CITY OF SAN ANTONIO

Re: Sulphur Springs

MDP # 875

The City Staff Development Review Committee has reviewed Sulphur Springs Master Development Plan **M.D.P. # 875**. Please find enclosed a signed copy for your files. Your plan was accepted however please note the following:

**SULPHUR SPRINGS
 MASTER DEVELOPMENT PLAN
 PLAN #
 DATE 9/23/05**

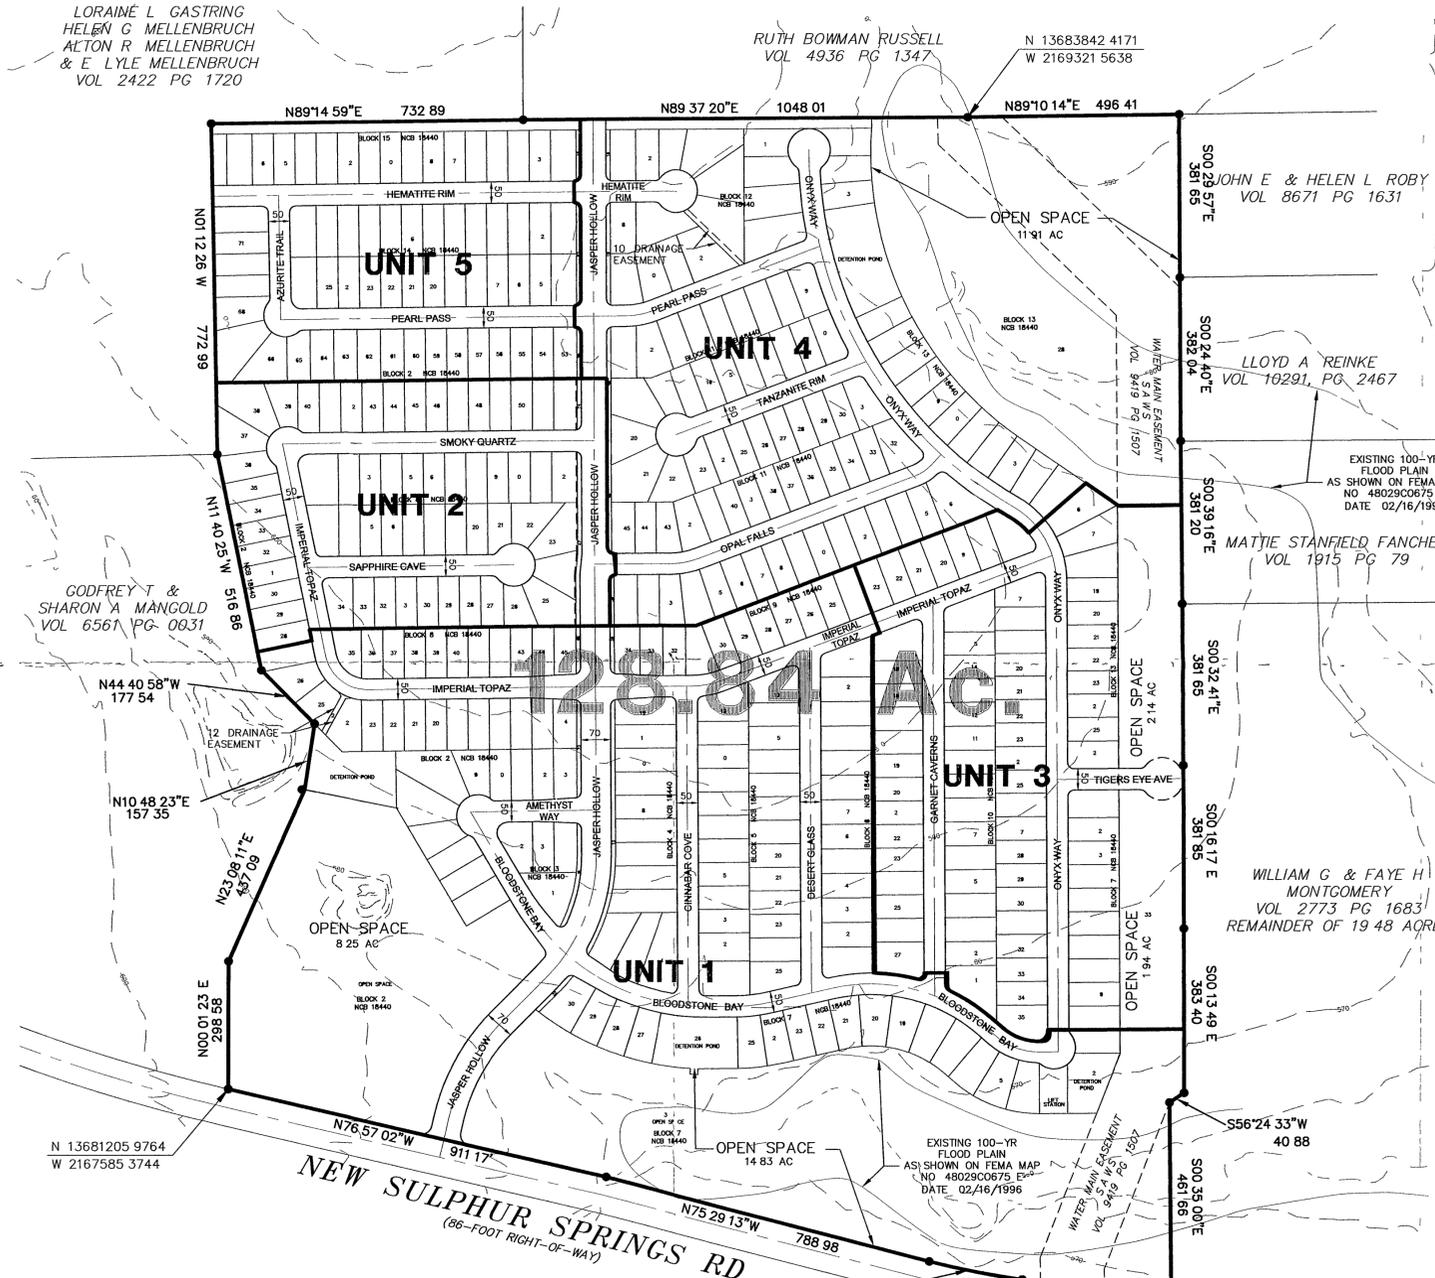
- In consideration of public safety and convenience, excessive grades by reason of topography should be avoided in street layouts and arrangements.
- Any access and R.O.W. issues along state facilities will need to be resolved with the **Texas Department of Transportation (TXDOT)**. For information about these requirements you can contact TXDOT at 615-5814.

- The developer shall be responsible for providing right-turn deceleration lanes as well as left turn lanes, with storage lengths and bay taper as it relates to the submitted TIA traffic counts, (Uniform Development Code (UDC) – 35-502(a)(7), subsection C. (174 PHT left turns and 94 PHT right turns into the subdivision).

- Streetscape Standards – New Sulphur Springs Road requires streetscape on existing ROW (it appears that preservation of existing trees may fulfill this requirement if they are on the ROW thus avoiding the plating and irrigation of new streetscape trees). The new ROW on Jasper Hollow (collector) will require streetscaping as well (again, we recommend preservation of existing trees where available and possible.)

- Final approval of this Master Tree Permit is conditional upon the inclusion of the tree save areas on the final version of the Master Development Plan. Please forward a copy to us when this has been placed on the plan.
-

- It will be expected that you will plat all of the property depicted in your Master Development Plan (M.D.P.) to include floodplains, drainage areas and open space.
